# ALERT SERVICE BULLETIN

## WINGS - FLIGHT CONTROLS — FLAPS - MODIFIED OUTBOARD FORWARD FLAP LINKAGE MODIFICATION N953

20 Feb 2008

# ANMD-27-53

Figure 4 Installation of Underwing Access Panel

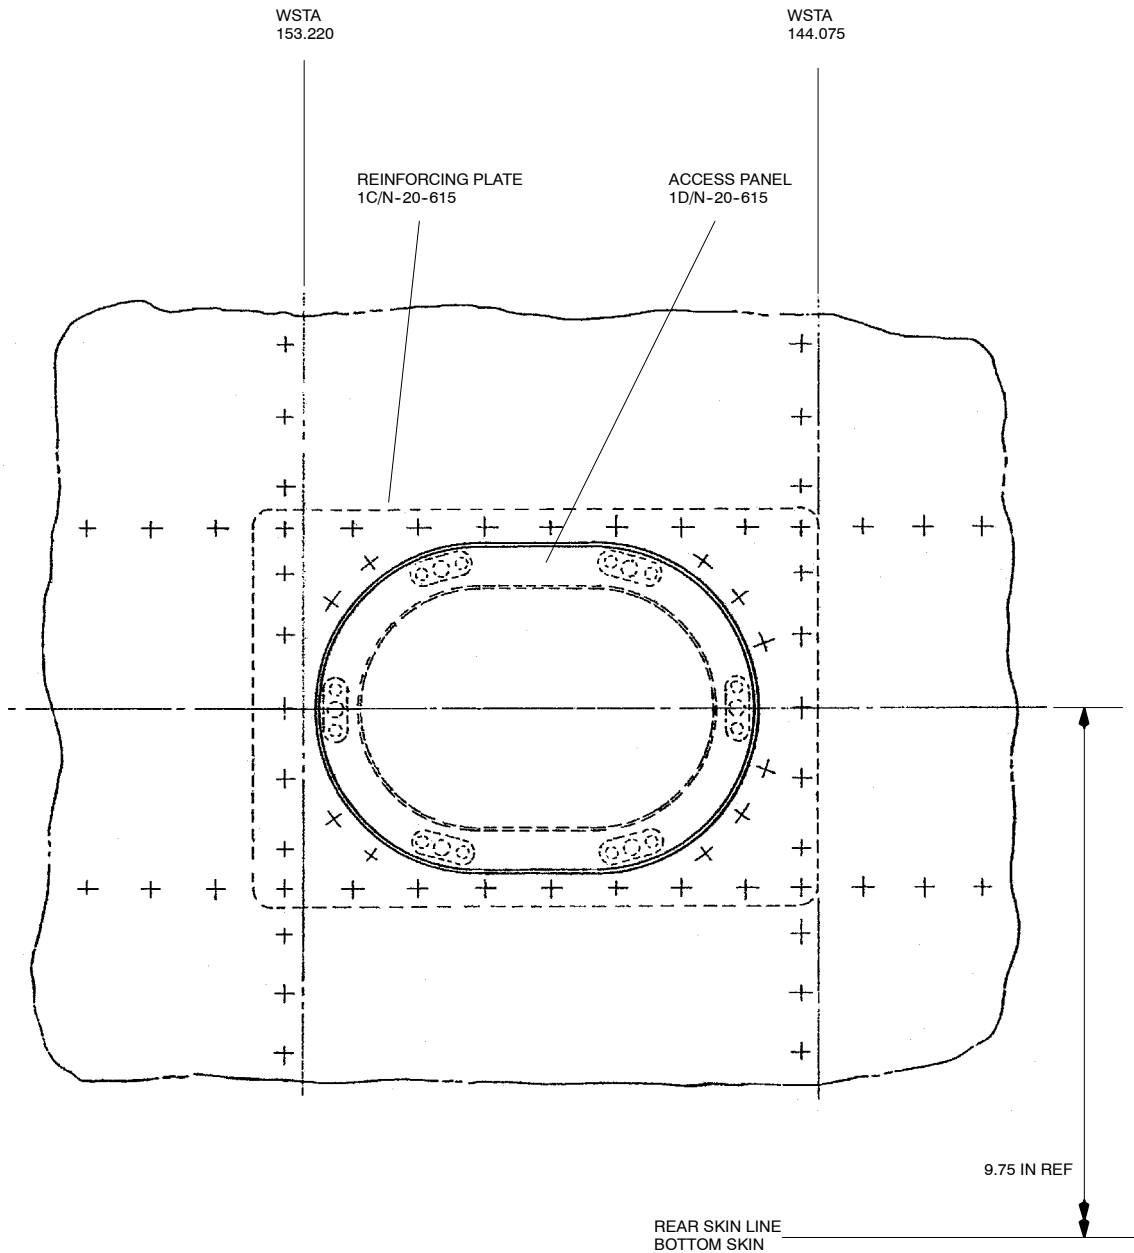
- (1) in order to access the head of the existing bolt that secures this Idler Arm, an access panel (P/N 1D/N-20-615) must be present (consistent with the fitment of Customer Option G99, Auxilliary Fuel Tanks) or be installed as follows (Ref Fig 4):

- (a) Cut hole in skin to match Access Panel, position as shown. Deburr and treat edges as per SRM Chapter 51-30-00, Paras 3. and 4.
  - (b) Remove 3 rivets past each edge of the intended position of Reinforcing Plate (P/N 1C/N-20-615).

- (c) Pass Reinforcing Plate through cut-out in skin, and place into position.
  - (d) Drill through existing rivet holes.
  - (e) Re-rivet (using Rivets MS20470AD4-3 or MS20470AD4-4 as required) to complete assembly.

Figure 5 Flap Hinge Bracket at wsta 172.75 – Required Rework

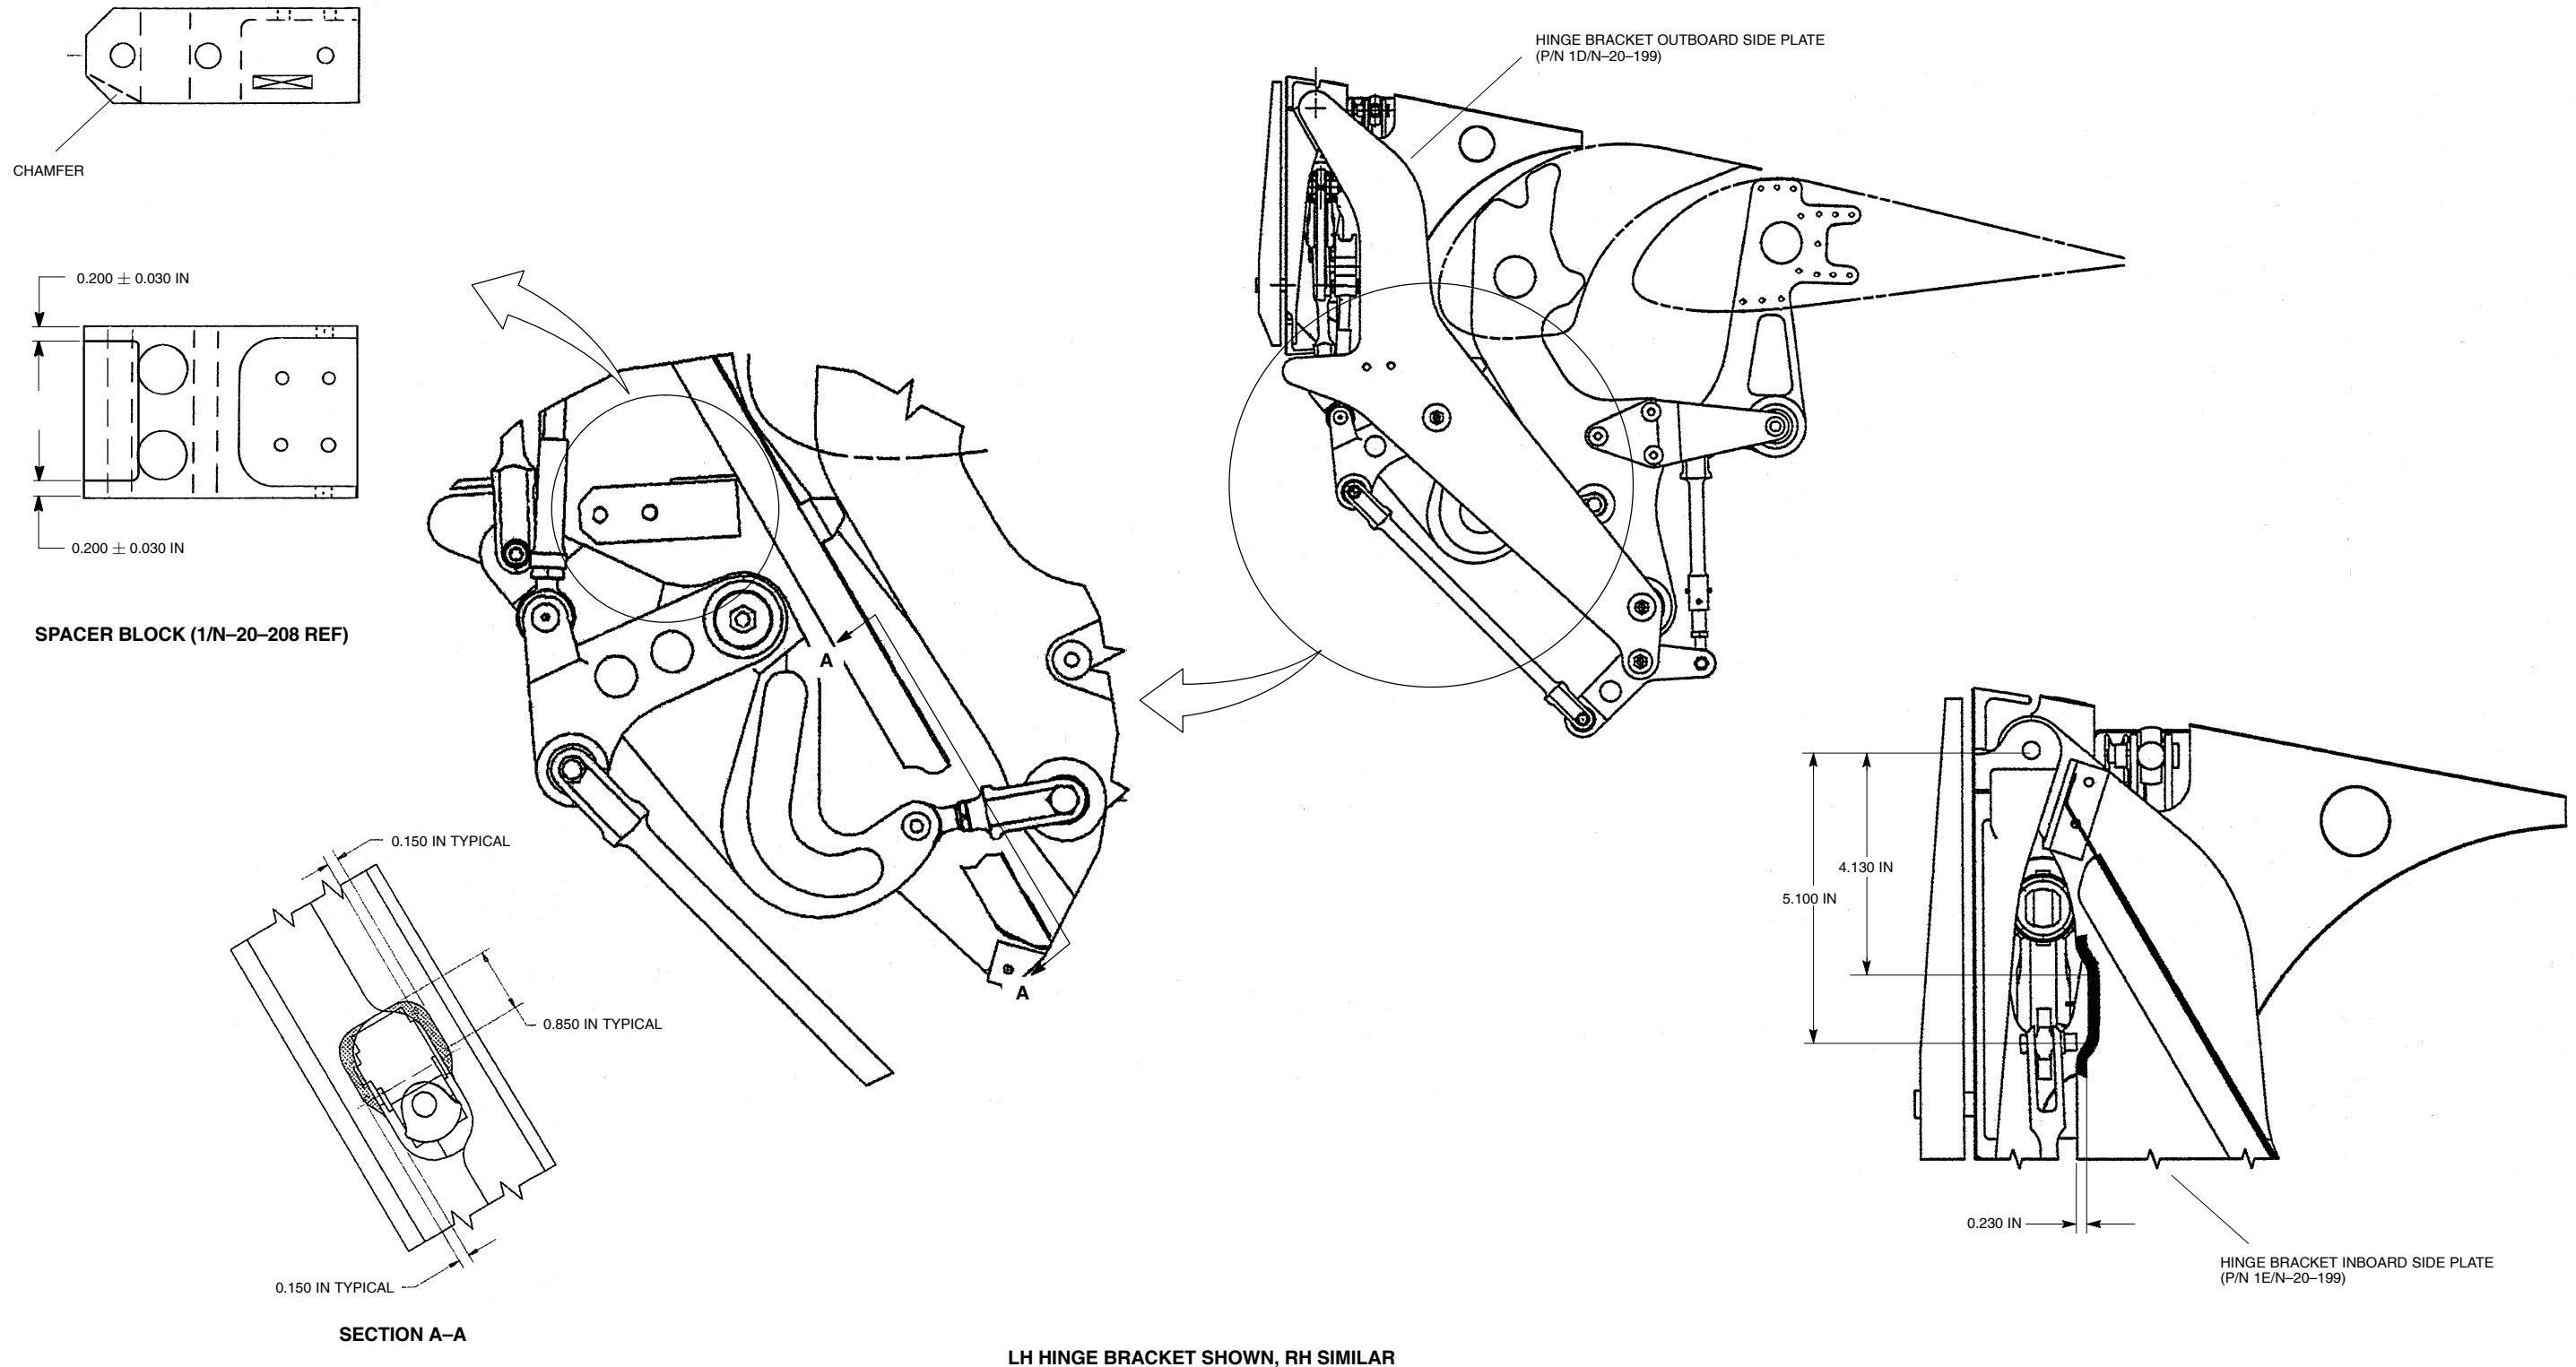
- (1) Rework Rear Web of Hinge Bracket (Ref Fig 5) to provide clearance for Goosecrank link.
- (2) Rework inboard Side Plate (P/N 1E/N-20-199) of hinge bracket assy (Ref Fig 5) to provide clearance between side plate and bolt fitted in new Bellcrank (P/N 1/N-45-1771) at wsta 175.97.
- (3) Chamfer Spacer Block (P/N 1/N-20-208) in hinge bracket (Ref Fig 5), to provide clearance for new Goosecrank (P/N 1/N-45-1765).

- (1) Rework Rear Web of Hinge Bracket (Ref Fig 5) to provide clearance for Goosecrank link.
- (2) Chamfer Spacer Block (P/N 1/N-20-208) in hinge bracket (Ref Fig 5), to provide clearance for new Goosecrank (P/N 1/N-45-1765).

Figure 6 Rework to Wing TE Rib 1C/N-20-459/460

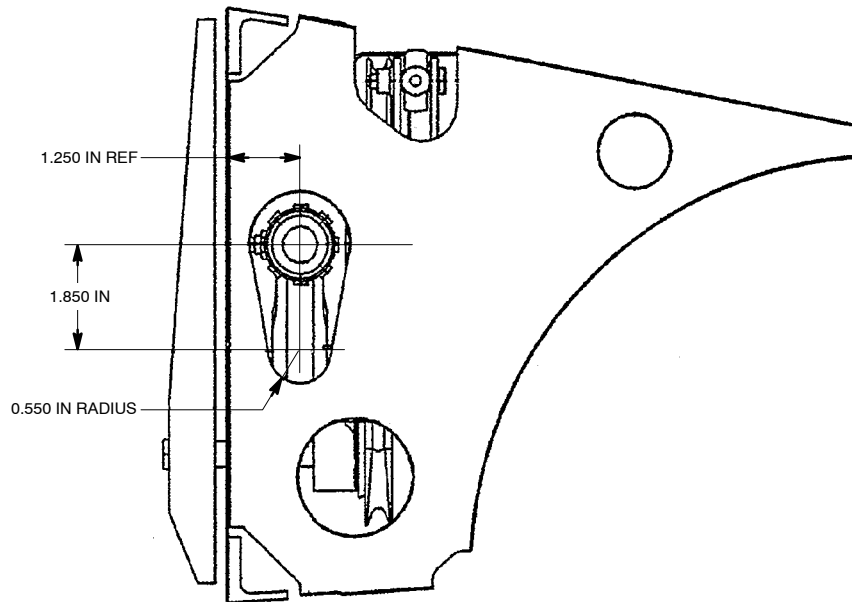
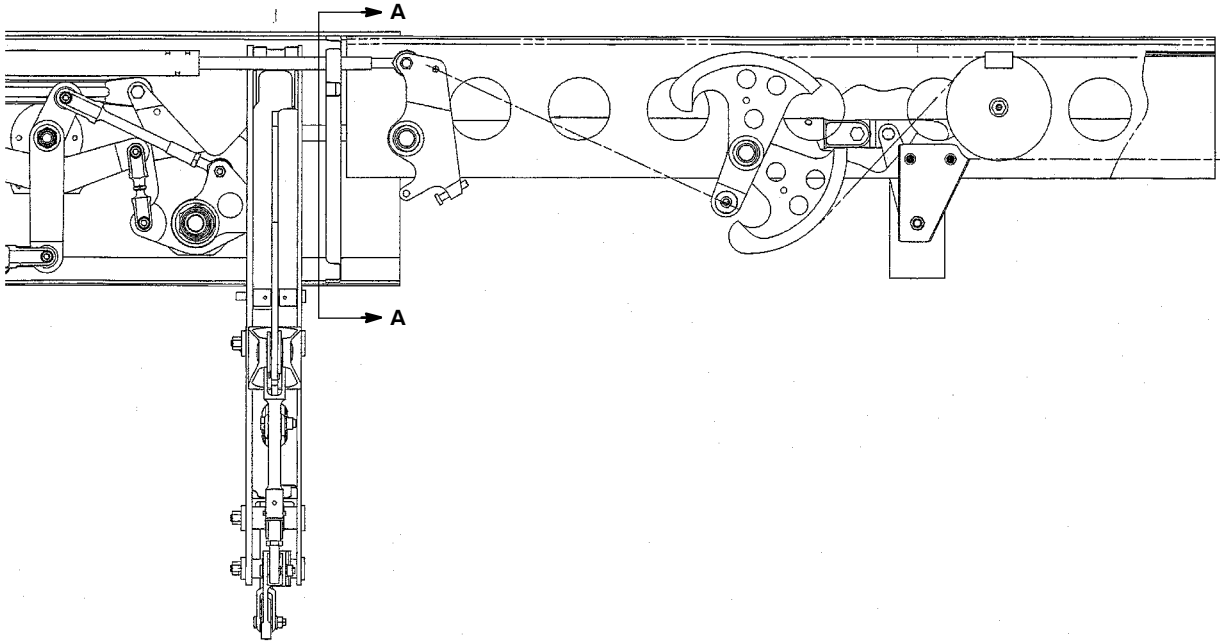
- (1) Rework lightening hole in T/E Rib 1C/N-20-459/460 (Ref Fig 6), to provide clearance for new Flap Control Rod with Flaps extended.

- REWORK AS FOLLOWS:
1. REMOVE LIGHTENING HOLE FLANGE
  2. OPEN OUT APERTURE AS PER THE DIMENSIONS SHOWN
  3. CLEAN, DEBURR AND TREAT EXPOSED METAL PER SRM

**Figure 7 Rework to Diaphragm 1M/N-20-459/460**

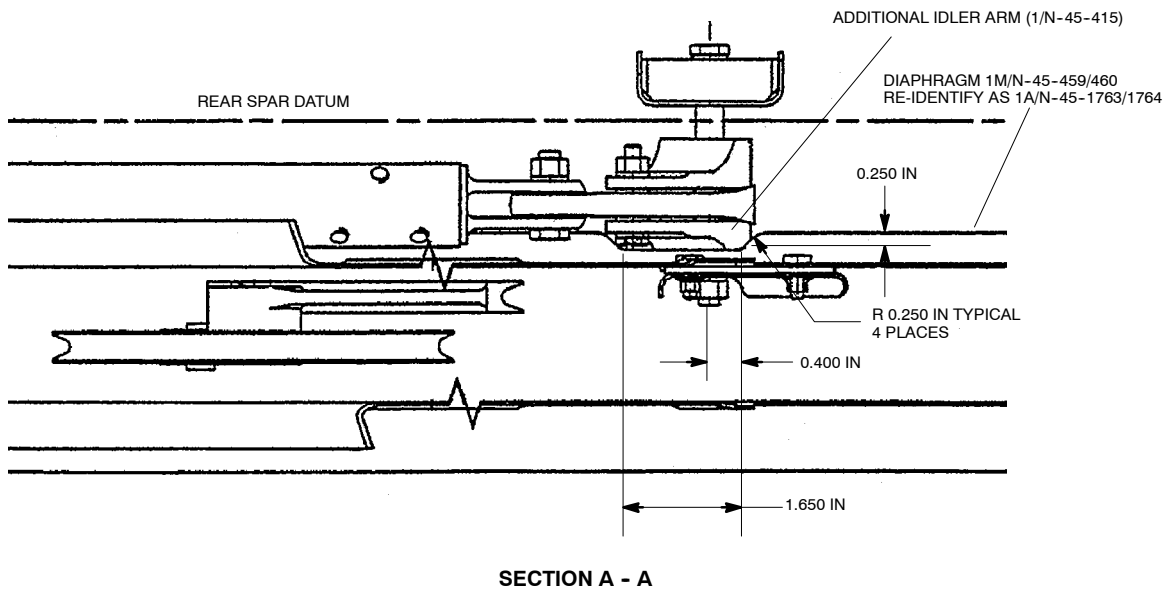
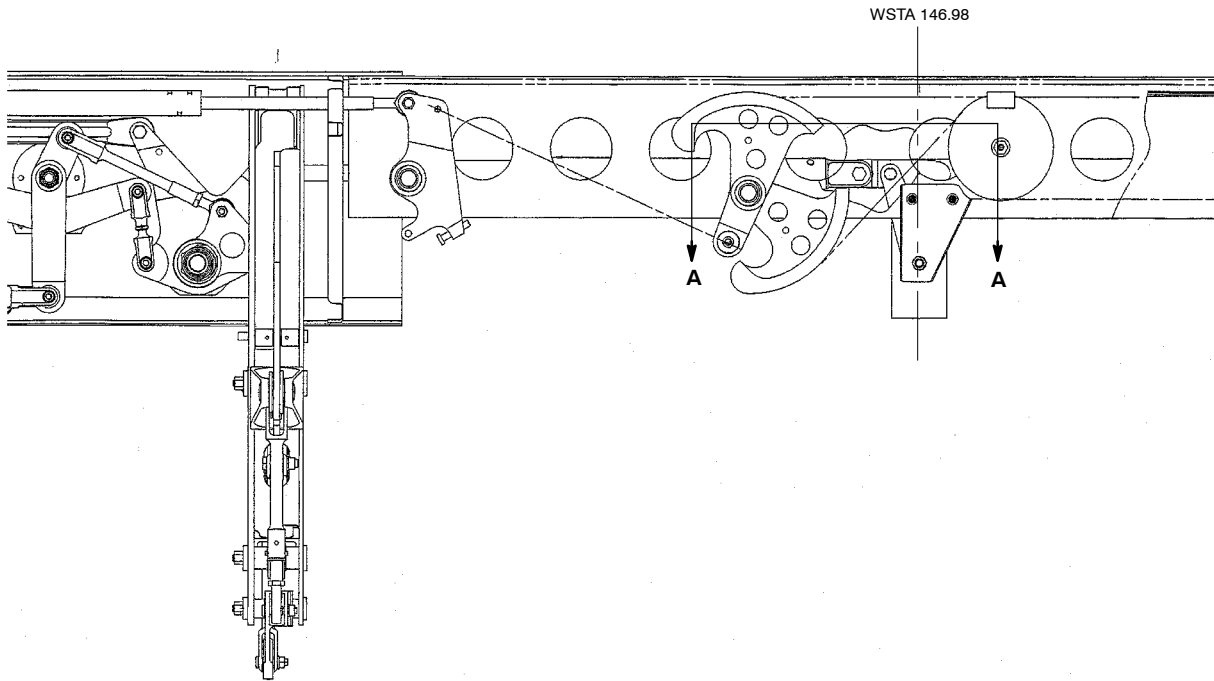
- (1) Rework lower flange of diaphragm P/N 1M/N-20-459/460 per Figure 7, to provide clearance between flange of diaphragm and the additional Idler Arm (P/N 1/N-45-415) at wsta 146.98)

- REWORK AS FOLLOWS:
1. NOTCH LOWER FLANGE OF DIAPHRAGM AS DETAILED
  2. CLEAN, DEBURR AND TREAT EXPOSED METAL PER SRM

**Figure 8 Installation of Duplicated Idler Arms at WSTA 146.98**

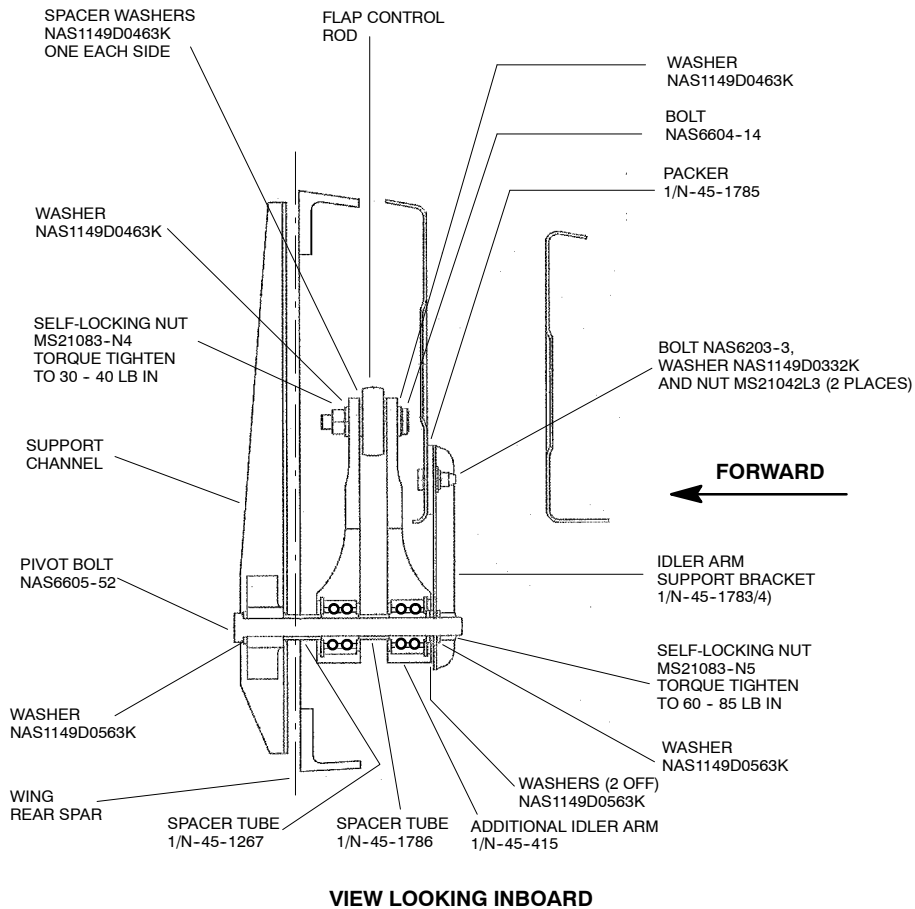
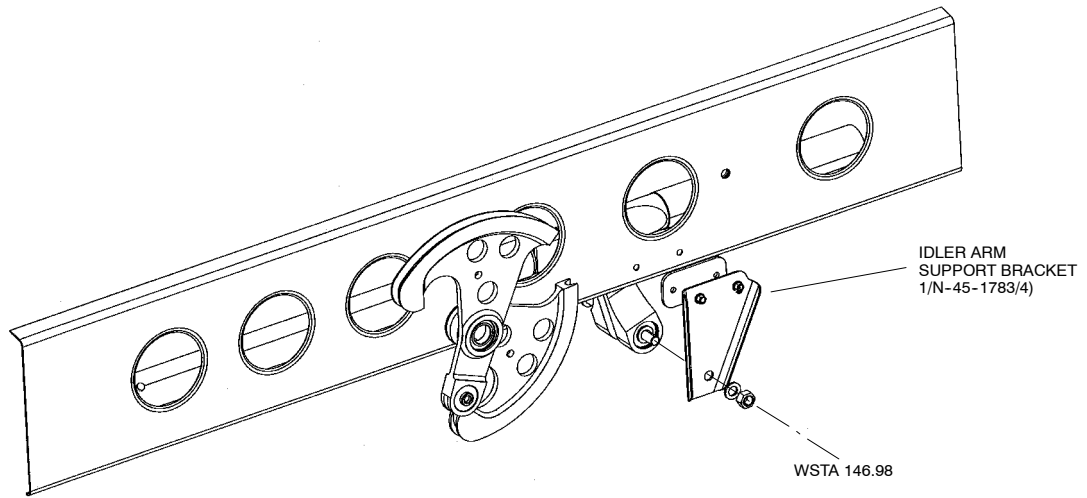
#### **E. Installation of Folded Bracket for new additional Idler Arm at WSTA 146.98 (Ref Fig 8)**

- (1) Reaming/cleaning out of bolt hole may be required in order to remove old loctite, prior to fitting bolt .
- (2) Fit new Bolt (P/N NAS6605-52) via the under wing access panel at WSTA 146 (Ref Para 2.E.(1)).
- (3) On Folded Bracket mark off hole centre as per Figure 8. Drill 8 mm, deburr and retreat.
- (4) With reference to Figure 8, loosely fit new Folded Bracket (P/N 1/N-45-1783/4) on bolt shank and locate Folded Bracket and new Packer (P/N 1/N-45-1785), match drill 0.1900 - 0.1907 in dia through web of diaphragm, 2 places.

Figure 9 Installation of new Flap Bellcrank and new Cam Follower arm.

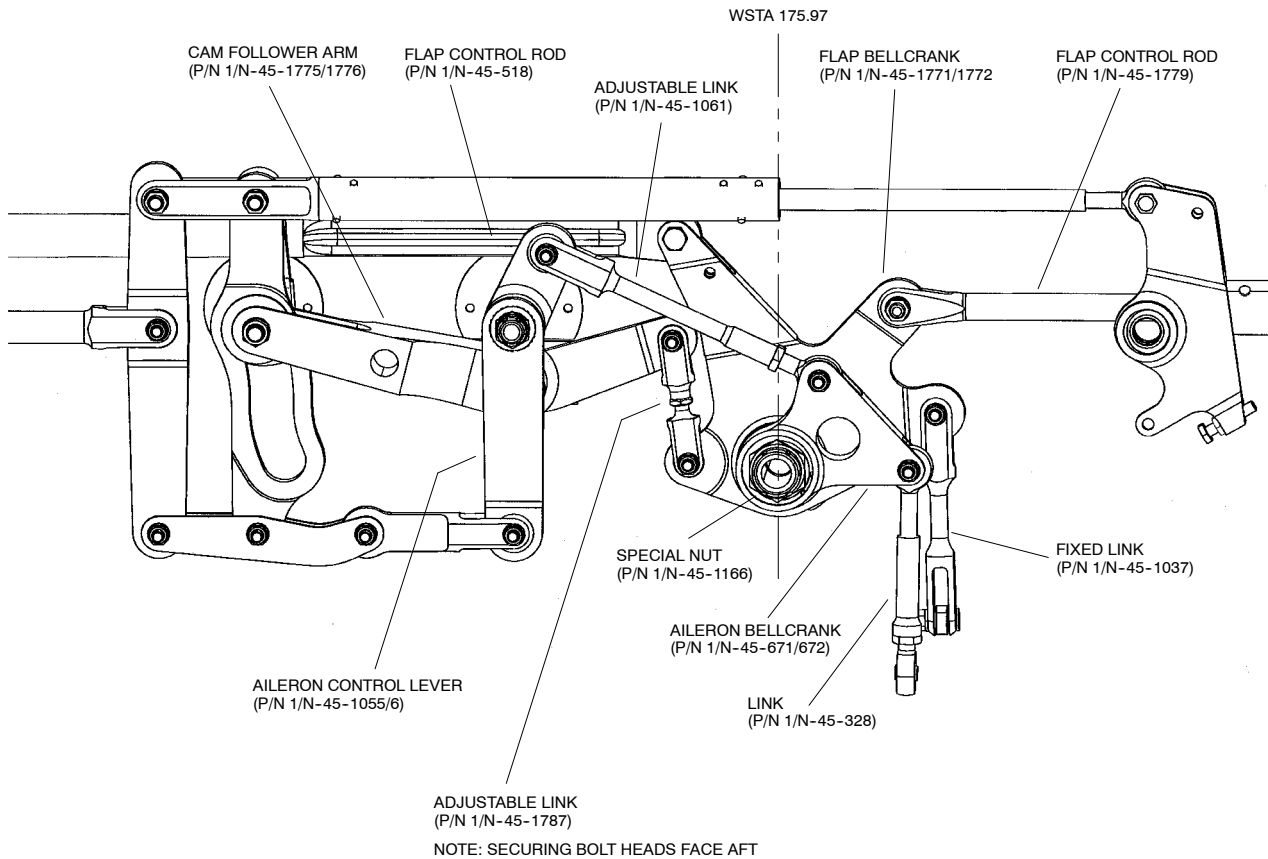
- (1) Fit new Bellcrank (P/N 1/N-45-1771/2) on spigot.
- (2) Attach existing outboard Flap Control Rod (P/N 1/N-45-518), new inboard Flap Control Rod (P/N 1/N-45-1779), existing fixed Link (P/N 1/N-45-1037) to the Bellcrank (P/N 1/N-45-1771/2) (Ref Fig 9).

### **C. Installation of new Cam Follower Arm WSTA 181.97 (Ref Fig 9).**

- (1) Fit new Cam Follower Arm 1/N-45-1775/6 (Item 6/7) over lower spigot, attach using existing Special Nut 1/N-40-683. Torque tighten to 45-55 lb in. and fit Cotter Pin.
